Typical details: where CAD and Revit draw the same detail differently

55 of the 190 CAD typical details have a Revit version in your templates that is drawn differently.

Compared by eye on 2026-10-23 from Nelson's CAD blocks and the Concrete Tower R24 / Steel R24 / Container R23 templates.

CAD: KOR-D302-DET 04 - BASEMENT WALL SECTION

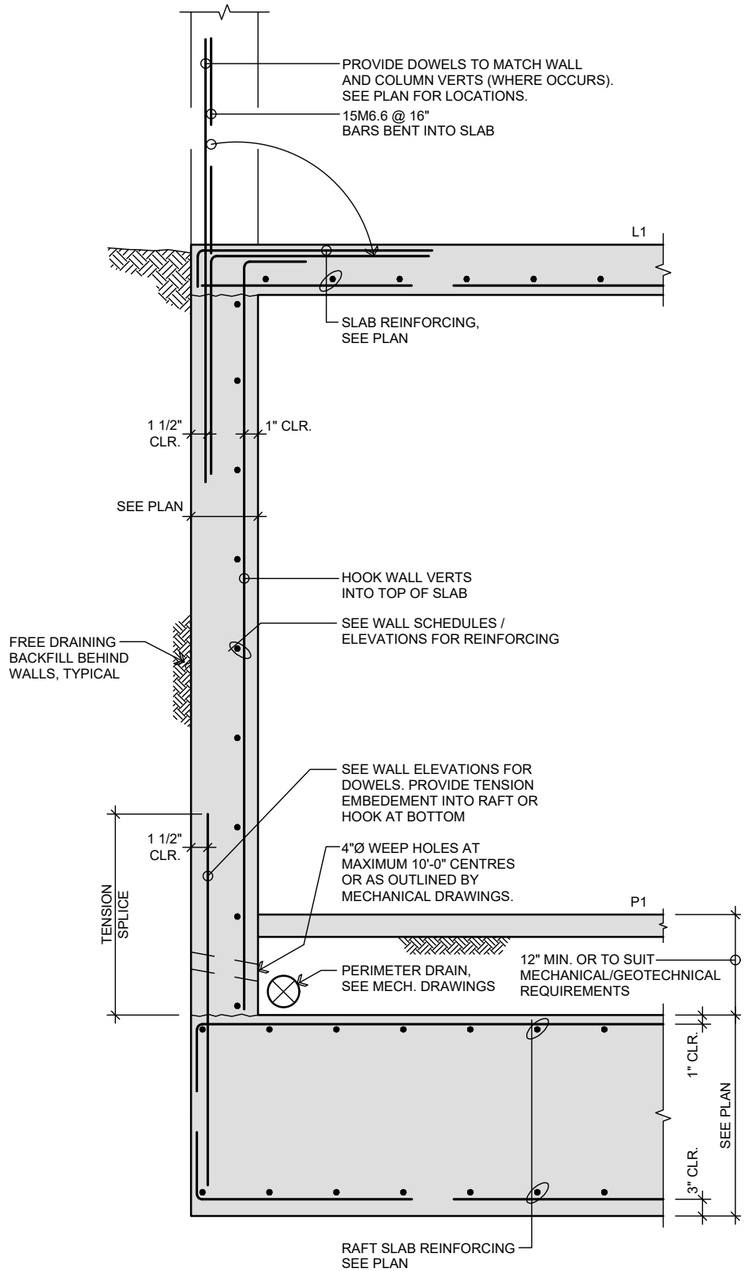
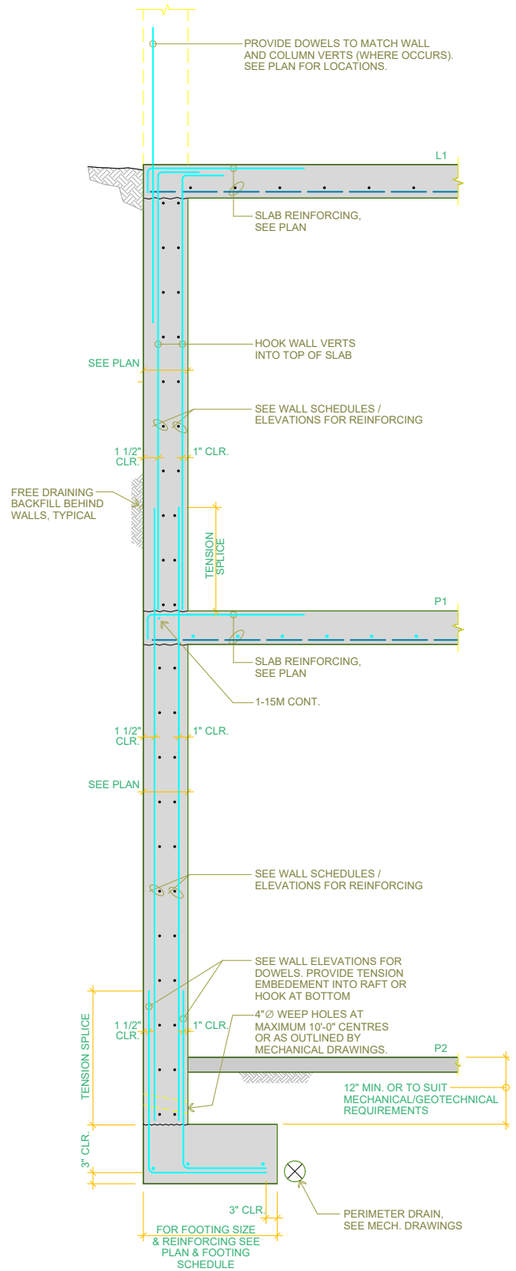
What differs: Single-storey basement wall on raft with slab dowel callout; 'D3.01_1_BASEMENT WALL SECTION' is three levels on strip footing.

23 of 55 CAD: KOR-D302-DET 05 - BASEMENT WALL SECTION

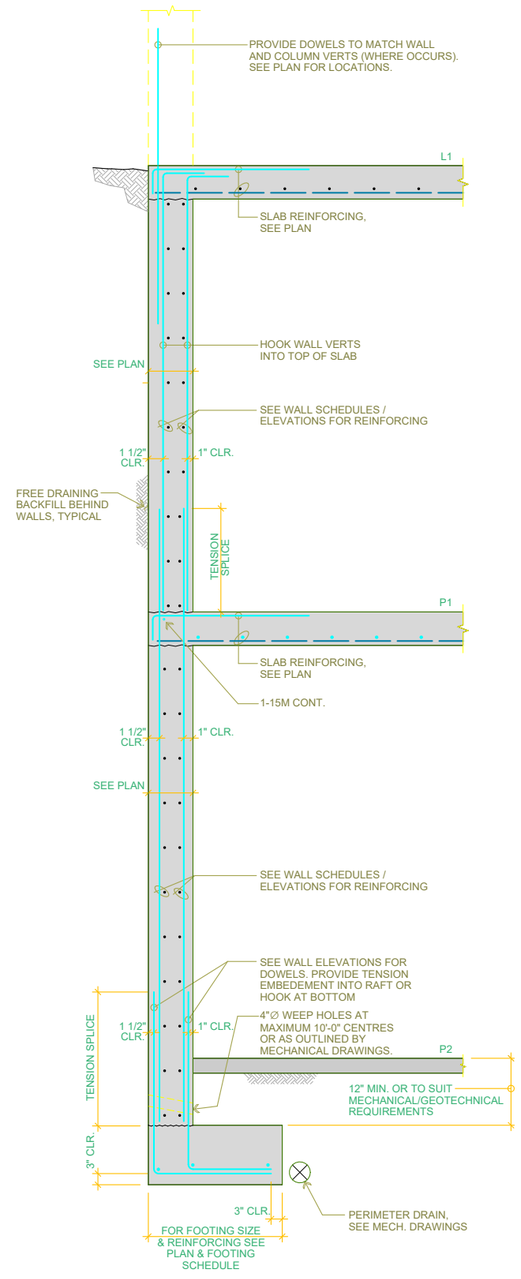
What differs: Tall multi-storey wall on raft; 'D3.01_1_BASEMENT WALL SECTION' is three levels on strip footing.

CAD: KOR-D302-DET 06 - BASEMENT WALL SECTION

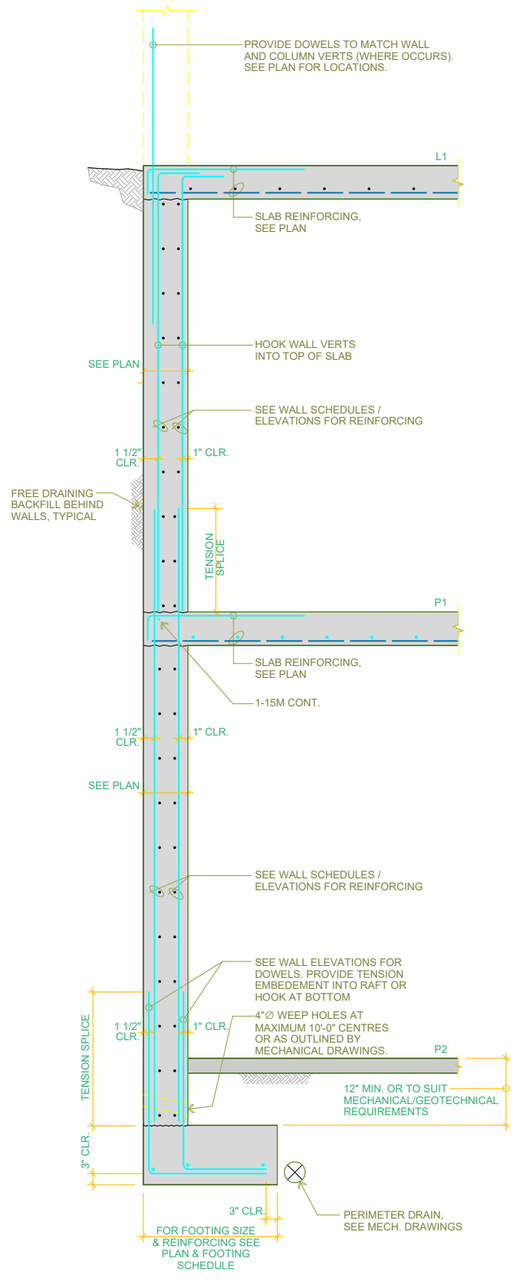
What differs: Tall multi-storey wall on raft; 'D3.01_1_BASEMENT WALL SECTION' is three levels on strip footing.

CAD: KOR-D302-DET 07 - BASEMENT WALL SECTION

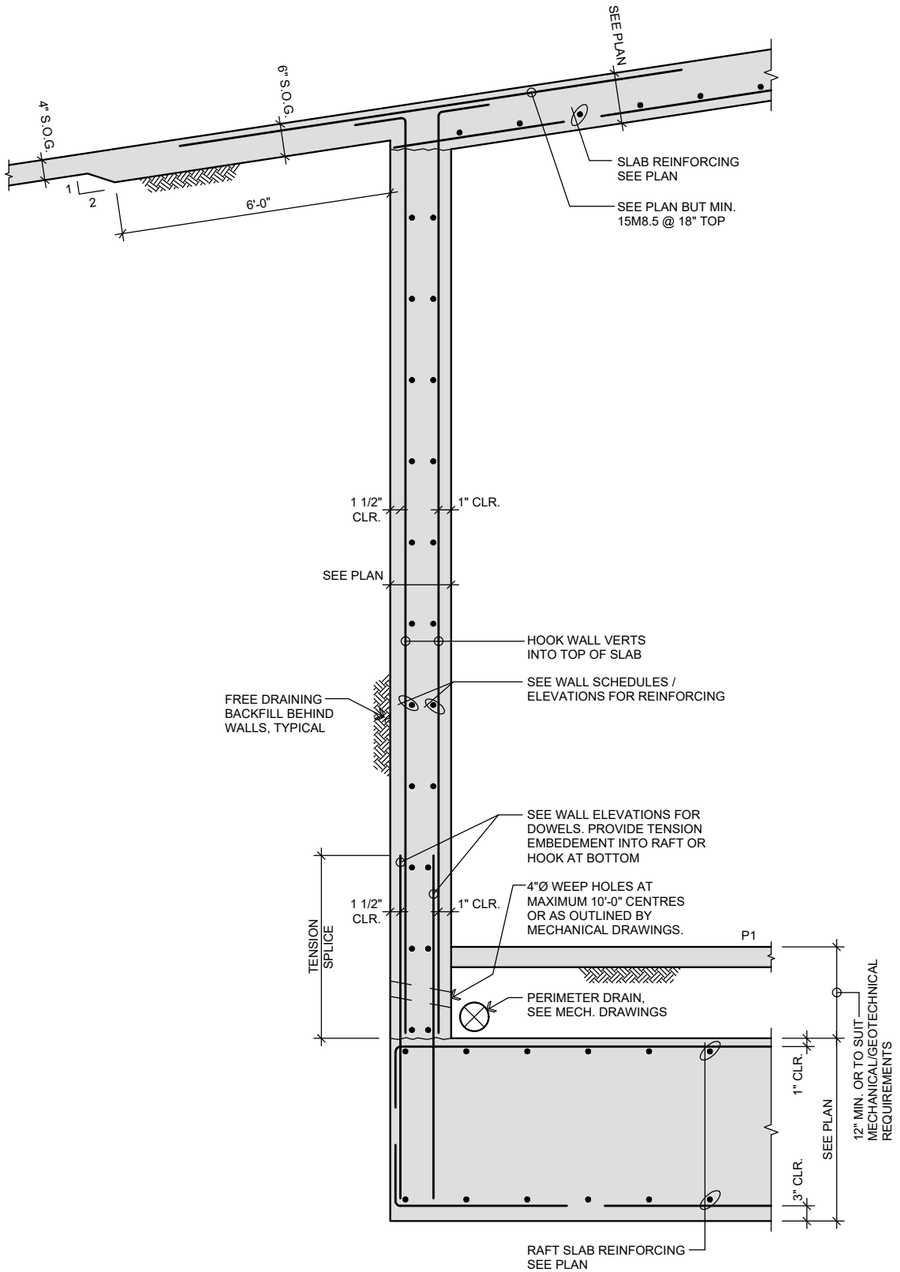
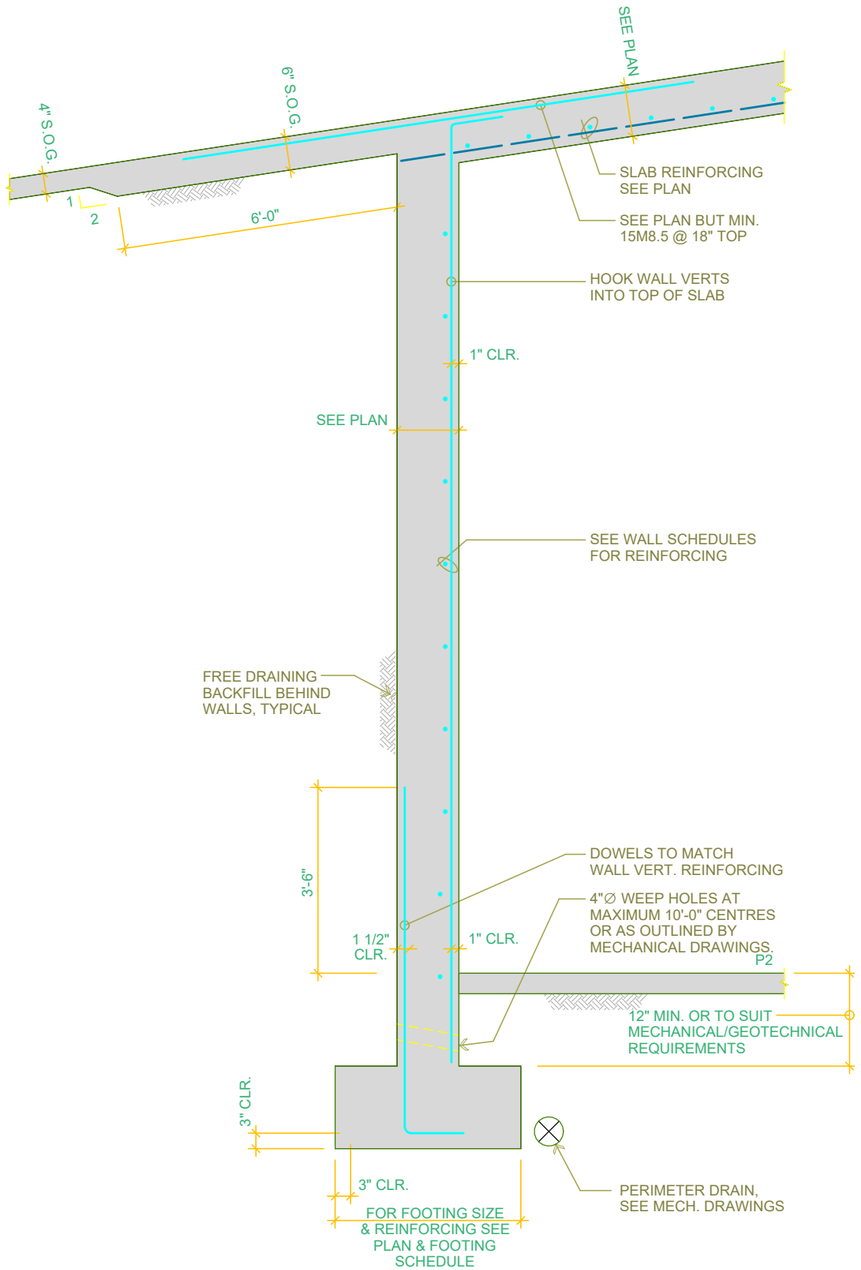
What differs: Wall with sloped slab over as 'S5.05_1_BASEMENT WALL DETAIL' but bearing on a raft rather than a strip footing.

CAD: KOR-D302-DET 08 - BASEMENT WALL SECTION

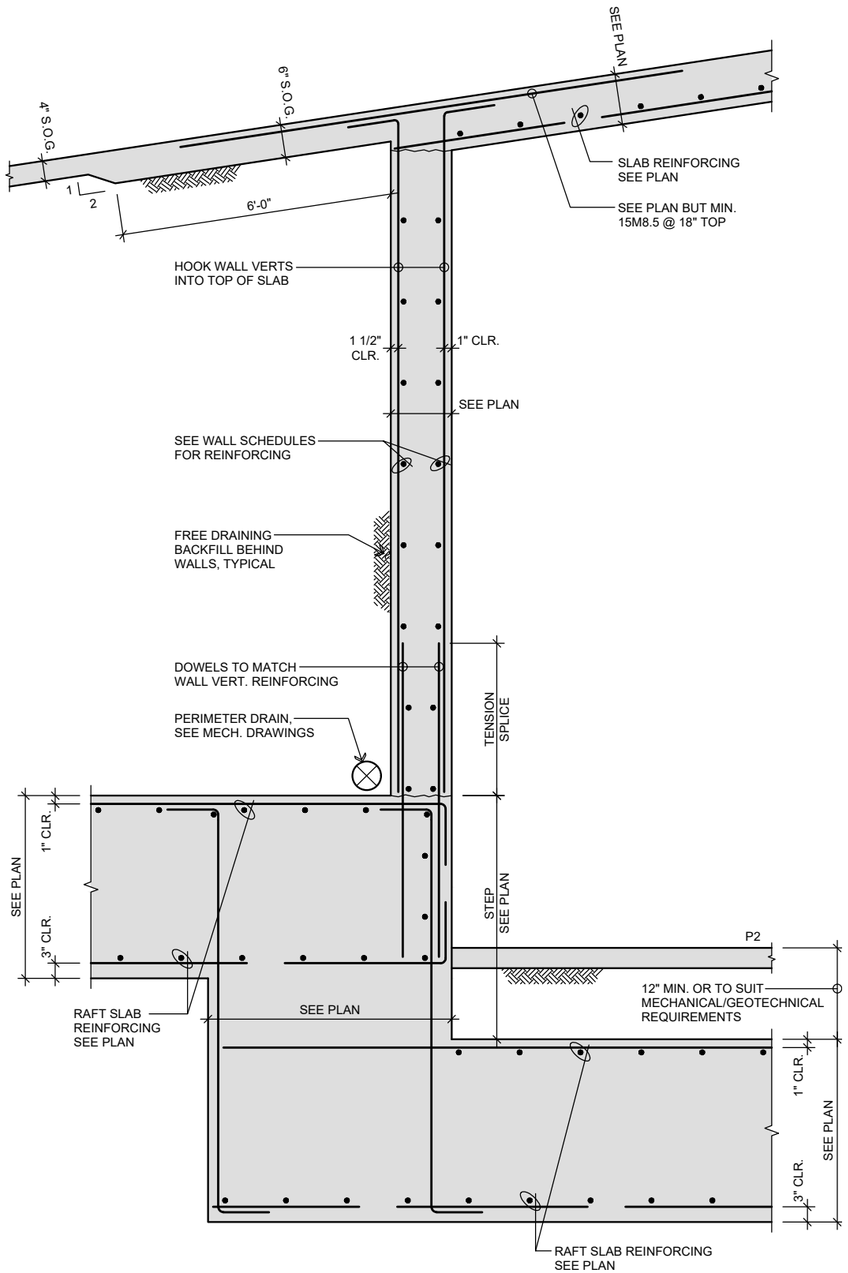
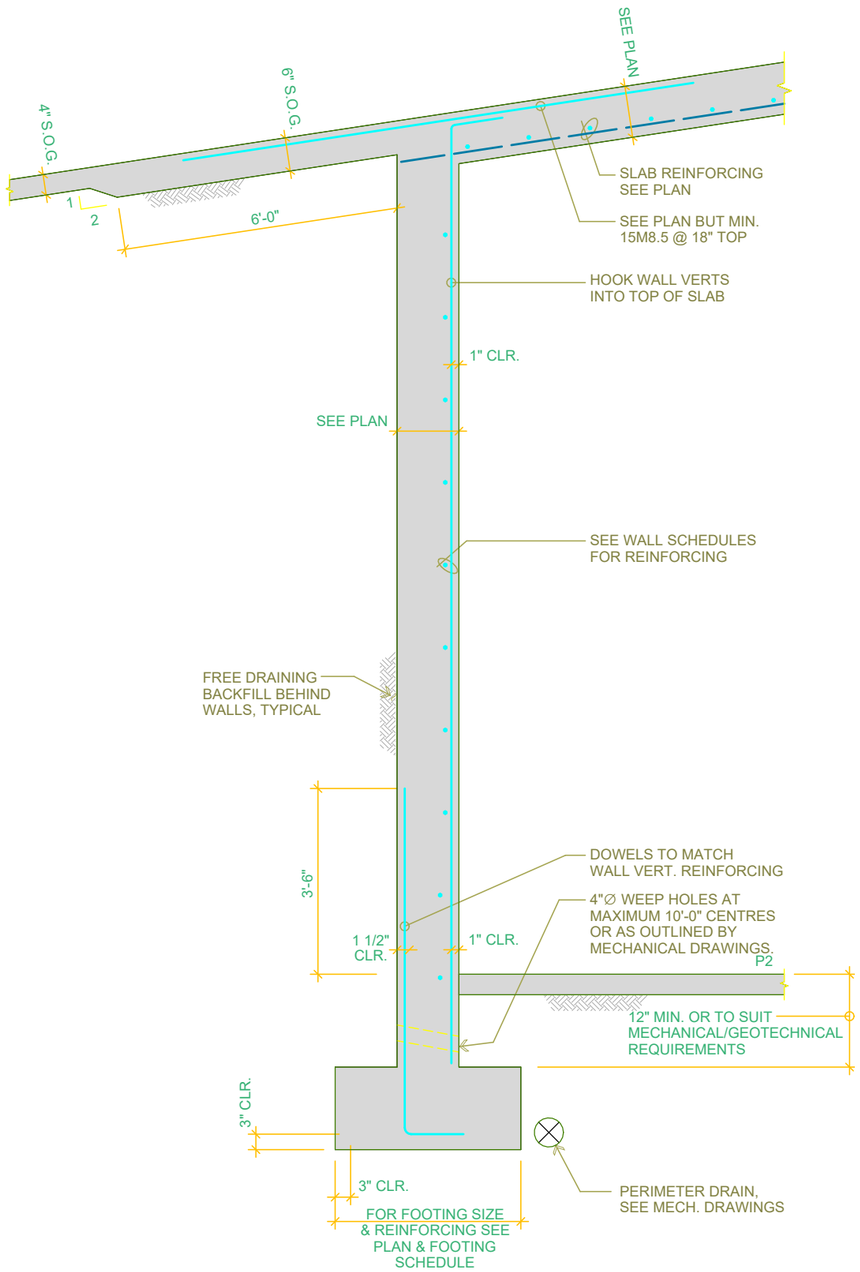
What differs: Wall with sloped slab over as 'S5.05_1_BASEMENT WALL DETAIL' but ending in a stepped raft rather than a strip footing.

CAD: KOR-D401-DET 05 - STEP SECTION

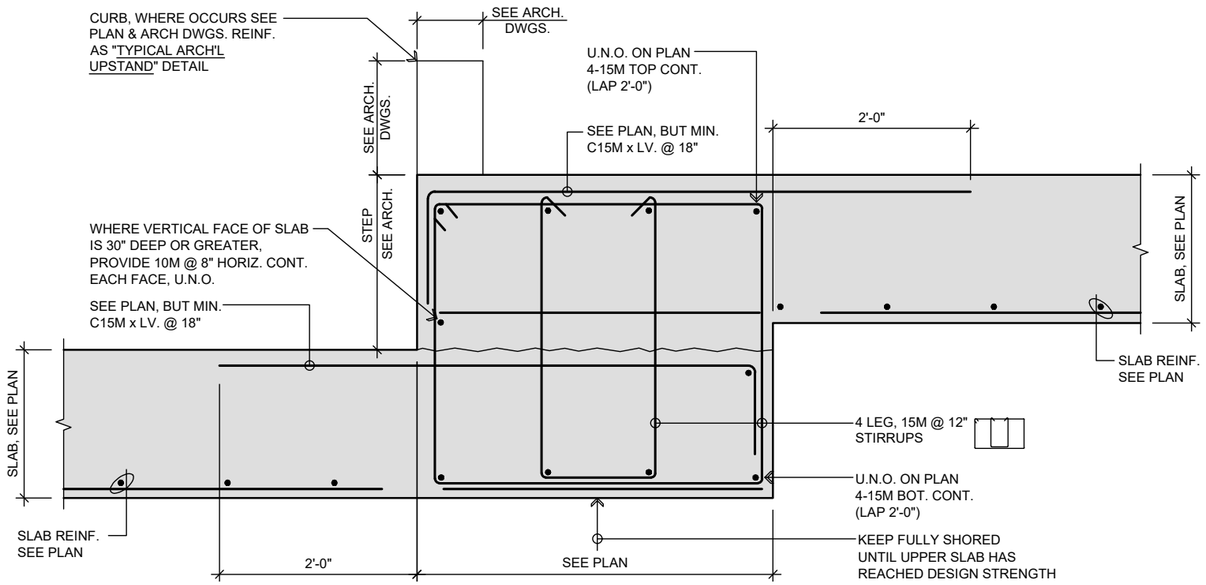
What differs: Step with curb and 4-leg stirruped beam at the step; 'D4.01_1_STEP SECTION' differs in geometry and bars.

CAD: KOR-D501-DET 14 - LOAD BEARING STEEL GRATING SECTION

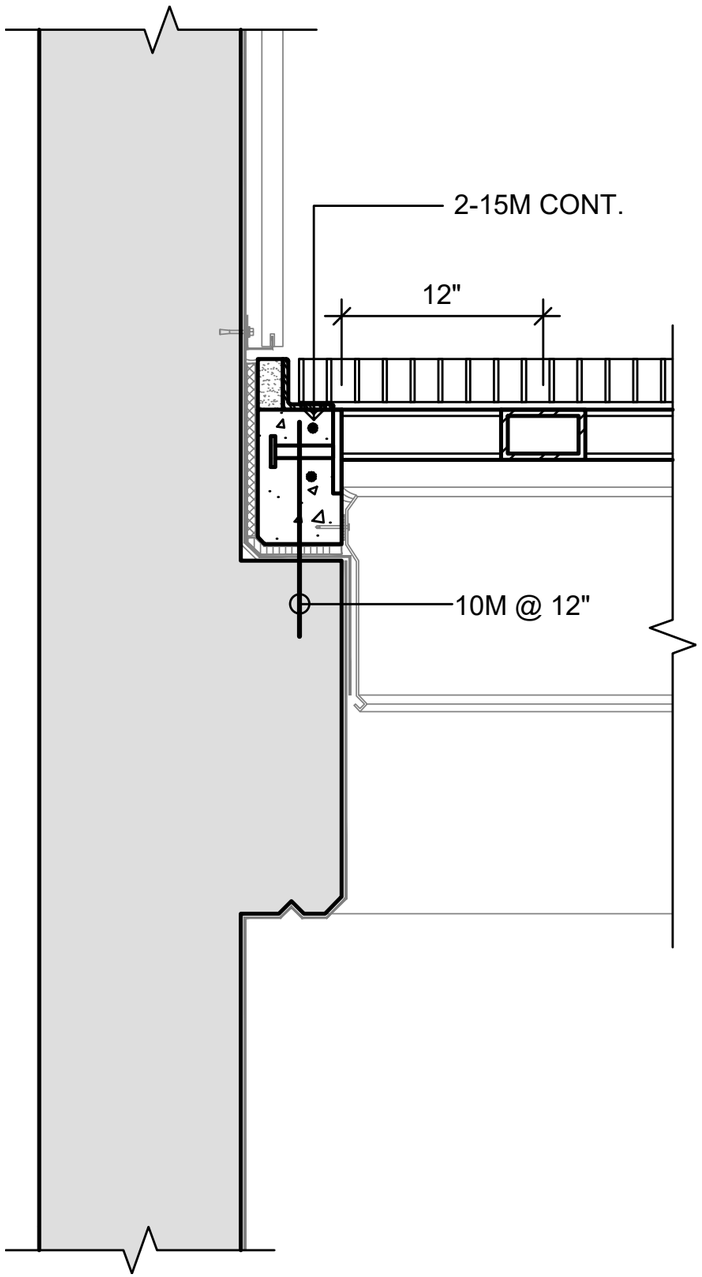
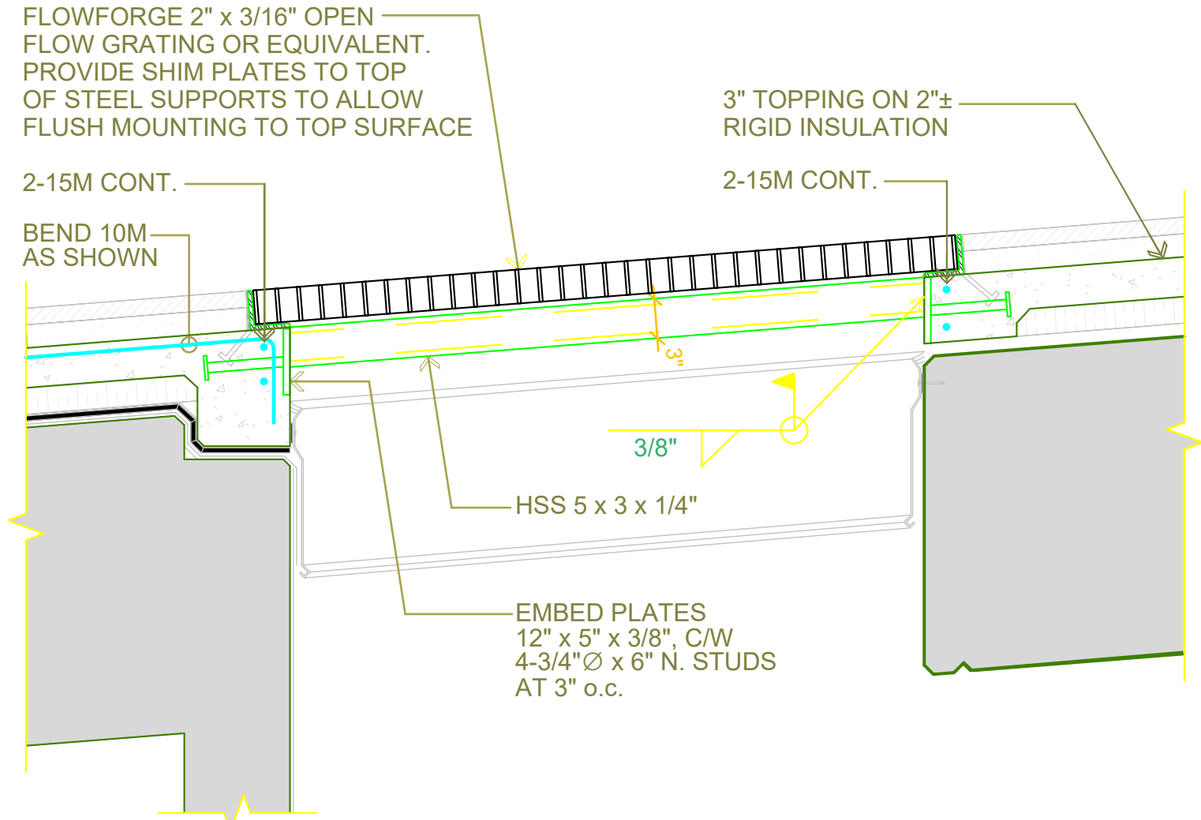
What differs: CAD is the grating support at a wall face with ledger and 10M dowels; 'D5.01_13_LOAD BEARING STEEL GRATING SECTION' is the grating spanning between slab edges.
